CALIFORNIA ENERGY COMMISSION

August 13, 2012

**RE: CALICO SOLAR PROJECT PV AMENDMENT (CSPA) (08-AFC-13C)
DATA REQUEST SET 1 (Nos. 1-81)**

Figure 2-2 from Original Calico Solar Project approval.

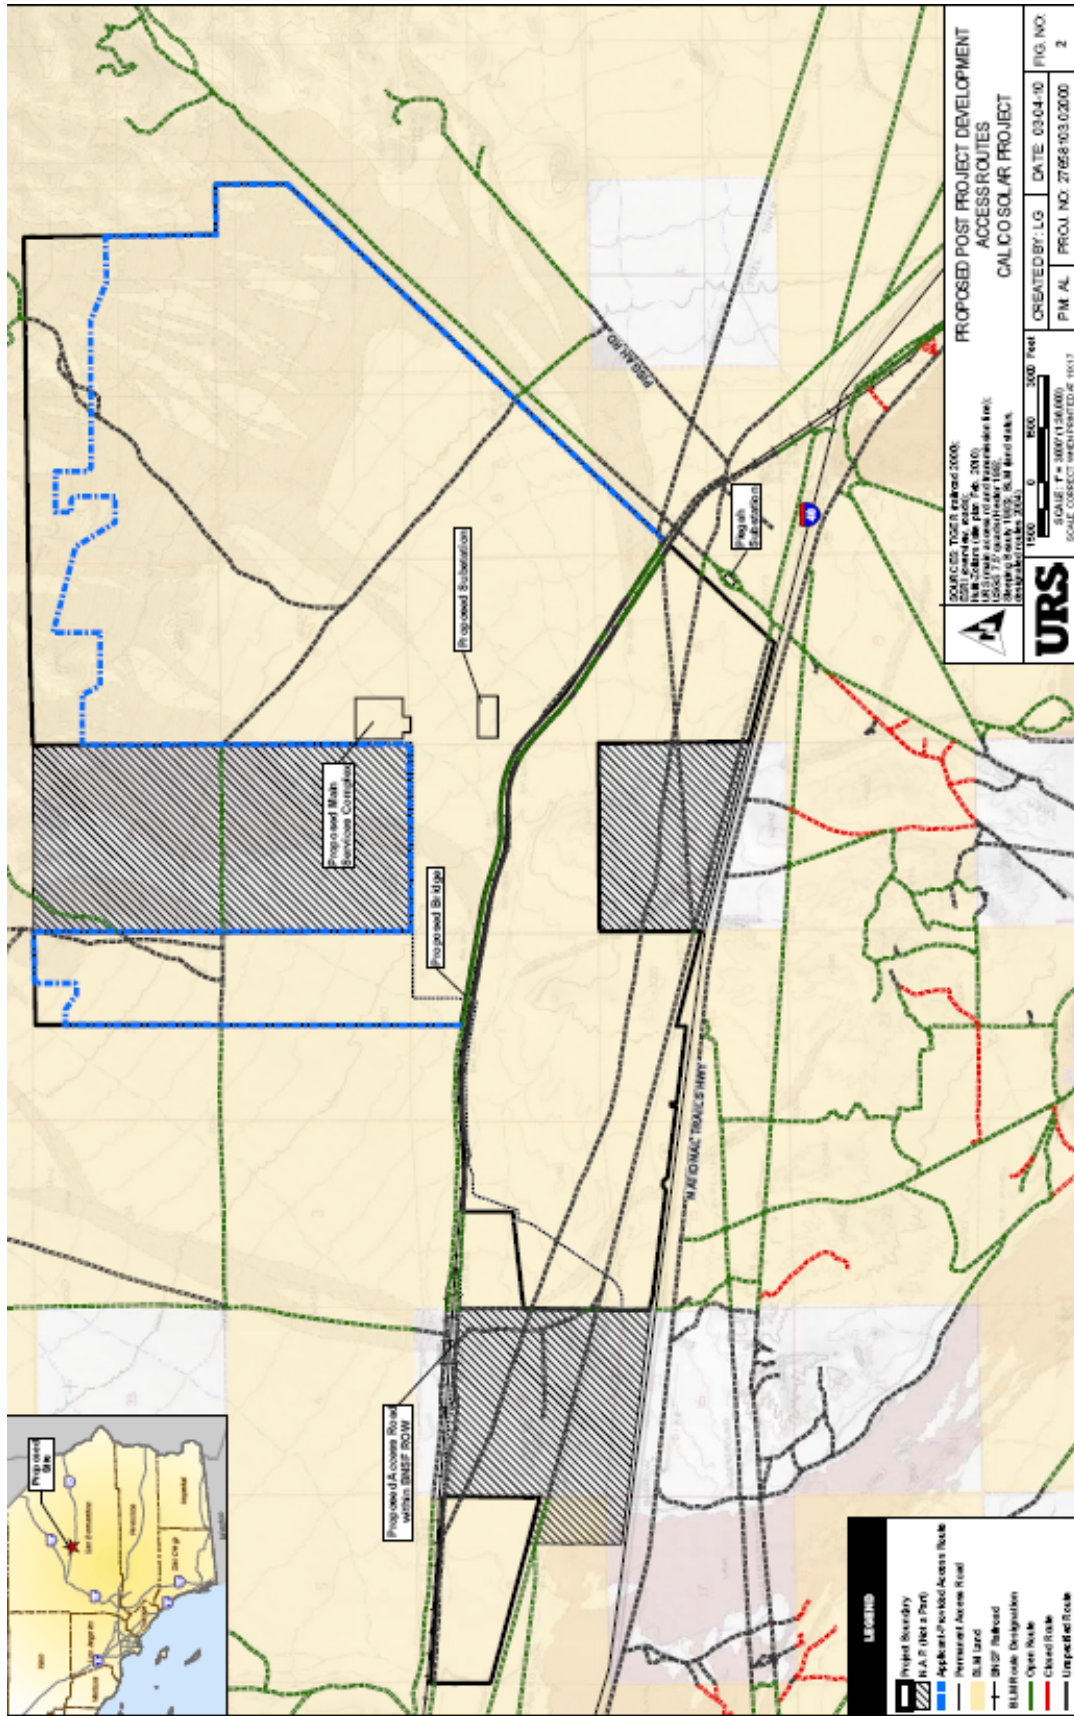
Figure 2-2, "Modified Project Layout", in the Petition to Amend does not show the project-provided access route that was included in the original project. This figure also does not seem to differentiate between BLM open routes, closed routes, and unspecified routes.

61. Please provide a figure similar to Figure 2-2 that includes:
- A. the project-provided access route included in the original project;
 - B. BLM open routes, closed routes, and unspecified routes.

See the attached figure on page 24 from the original project for details.
